Delegated Report

Householder Planning Application

Planning Application No: 20250563

Description: Formation of vehicular access and provision of one parking space in front garden.

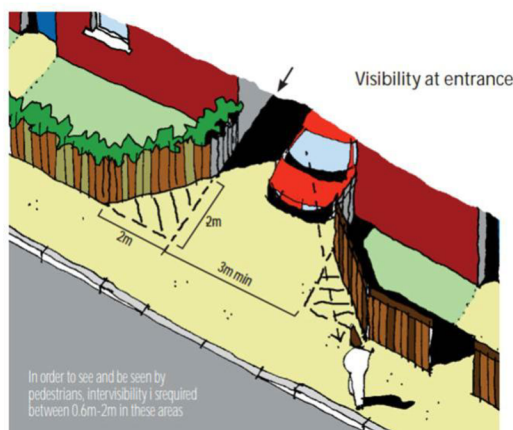
Pedestrian visibility splays measuring 2 metres by 2 metres, measured behind the footway either side of the vehicle crossover, with no obstructions exceeding 0.6 metres above carriageway level within the splays, must be demonstrated on a scaled plan. The applicant is required to provide updated drawings accordingly and a diagram from KCC's Kent Design Guide showing pedestrian visibility splays is included below for the applicant's reference.

Having reviewed the plans it is uncertain if the required pedestrian splays can be achieved within the red line boundary (RLB) of the site. Furthermore, the brick pillars proposed to be retained are highly likely to fall within these splays and cause an obstruction. Reduction of the brick pillars to a maximum height of 0.6 metres above carriageway level may be required if they are to be retained.

20110975 refusal and dismissed on appeal

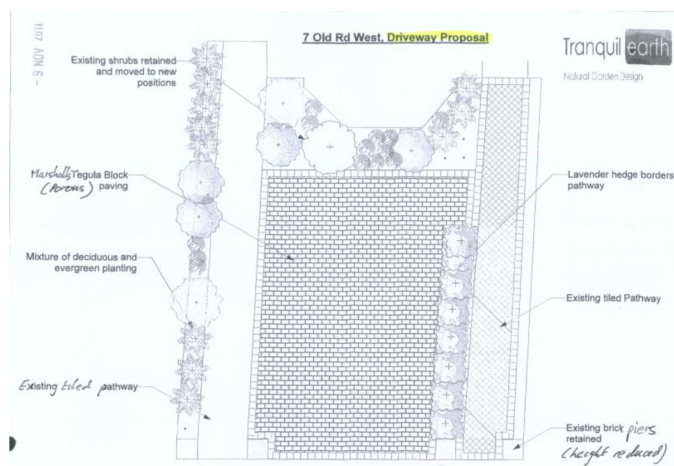
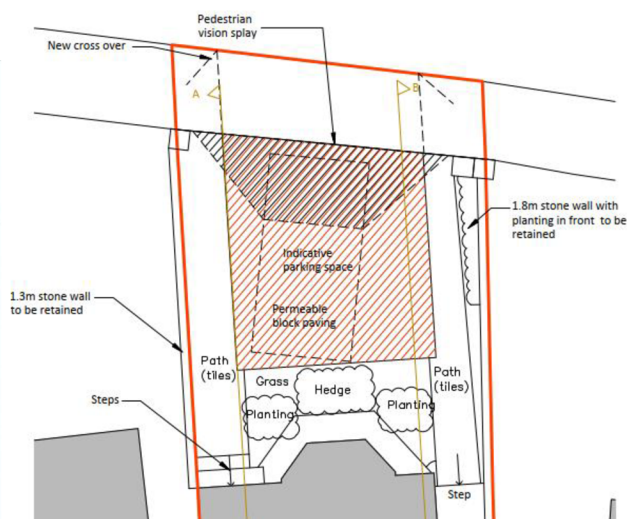
As the following images illustrate, the refused proposal is very similar to the current one and therefore the Inspector's comments are very relevant to the consideration of this application;

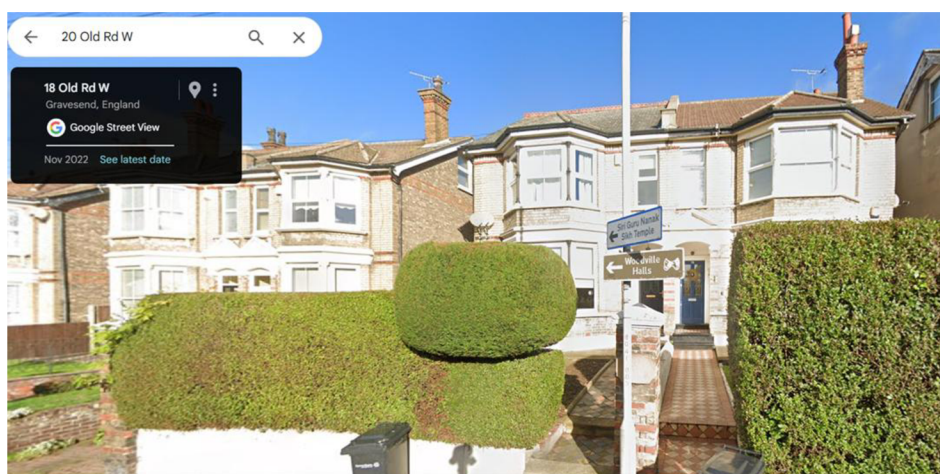
The proposed development would retain existing decorative tiled paths in the front garden which is welcomed but there would be no repair or restoration of these features. For example, the path on the

western side of the front garden has missing tiles near the frontage. This is a negative design feature and is contrary to the Householder Extensions/Alterations Design Guide (2021) and the GBC Front Driveway Guidance 2023.

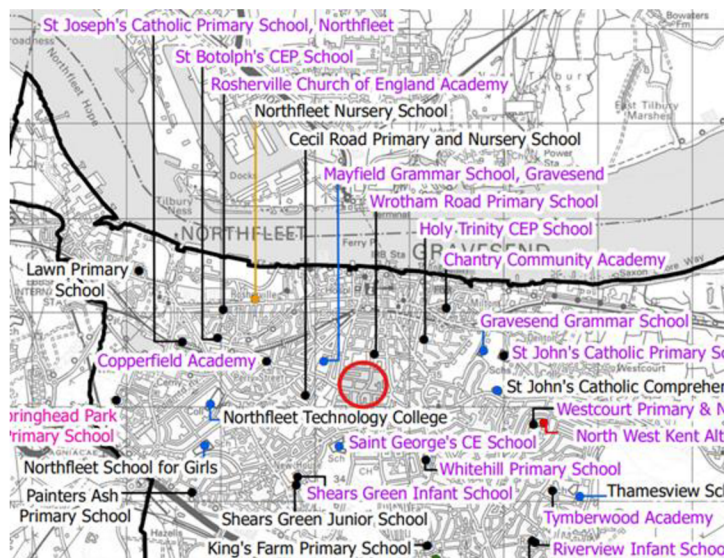
The application property has four bedrooms and no on-site parking at present. The proposed development would result in the provision of a frontage parking area with dimensions 5.1 metres (width at front boundary), 5 metres (width at rear) and 6 metres (depth on the western side) and 5.2 metres (depth on the eastern side). Therefore, the proposed parking area would exceed the minimum standard size for one parking space and could actually accommodate two vehicles. Although it is noted that the proposal shows an indicative parking space with dimensions of 2.5 metres width by 5 metres depth.

Whether one or two parking spaces are provided, the proposed development would still not provide the three parking spaces required under the adopted standards. Although it is noted that KCC Highways & Transportation have provided more recent guidance (as yet unadopted) that requires a minimum of two spaces to be provided for a four or more bedroom property in a suburban location (Kent County Council's Parking Standards January 2025). It is also noted that the application site is located in a relatively

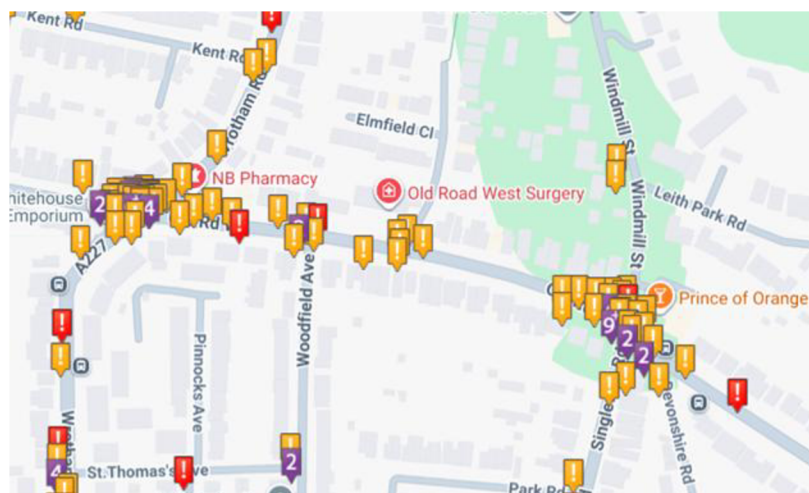
The proposed development would retain three brick pillars on the site frontage. Two, located on either side of the driveway, are 1.4 metres tall and on eastern side, a further brick pillar of 2.2 metres height (that is only partially within the ownership of the applicant) would be retained. Furthermore, both side boundary walls would be retained. The western wall is 1.8 metres tall and the eastern wall is 1.3 metres in height.

The distance from the edge of the proposed parking area to the side boundary of the application site is only 1.2 metres on the western side and 1.6 metres on the eastern side. The pillars and walls referred to above would be located within these areas and within a two metre distance set back into the site. Therefore, insufficient sized pedestrian visibility splays would be provided and these splays would include obstructions over 0.6 metres in height within them. This design approach would therefore be detrimental to pedestrian visibility and undermine highway safety by virtue of increasing the potential for hazardous manoeuvres, which would cause dangers to passing pedestrians.

Whilst it is acknowledged that KCC Highways & Transportation have offered a potential solution to the pedestrian visibility issue (one which the applicant has indicated would be acceptable to him), an ownership issue and the adverse visual impacts of removing large areas of side boundary walls and brick piers would mean that this would not be an achievable or welcome approach. Furthermore, due to the, in principle, highway safety issues raised in the following paragraphs, the applicant has not been asked to amend the proposal.
